RE: The Domain Rezoning – C14-2010-0015 - 169.7386 Acres Located at 10712, 10728, 10800, 11000, 11500, 11600 Burnet Road; 11601 Domain Drive; 2900, 3001, 3101 Esperanza Crossing (the "Property"); Proposed Rezoning from MI-PDA Zoning to MI-PDA Zoning

ZONING CHANGE REVIEW SHEET

CASE: C14-2010-0015 (The Domain Rezoning-Endeavor) **P. C. DATE:** July 13, 2010

SUBJECT: C14-2010-0015 (Endeavor Domain)

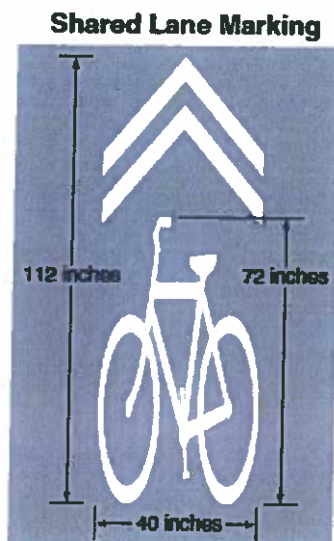
The City of Austin Bicycle Program recommends the applicant provide a bicycle network through the property to provide enhanced bicycle accessibility to and within the site. We hereby request this comment be incorporated into the staff recommendation.

2. The exhibit provided by the applicant should be updated to remove sharrows from Rock Rose Ave. and add sharrows to the following streets:

- Domain Drive between Alterra and Domain Blvd.,
- Domain Drive between Domain Blvd. to Esperanza on the east side of the street only (note: Endeavor does not own or have control over the west side of the street).
- Esperanza between Alterra Parkway and Burnet Road, and
- Kramer Lane extending to the western property line.
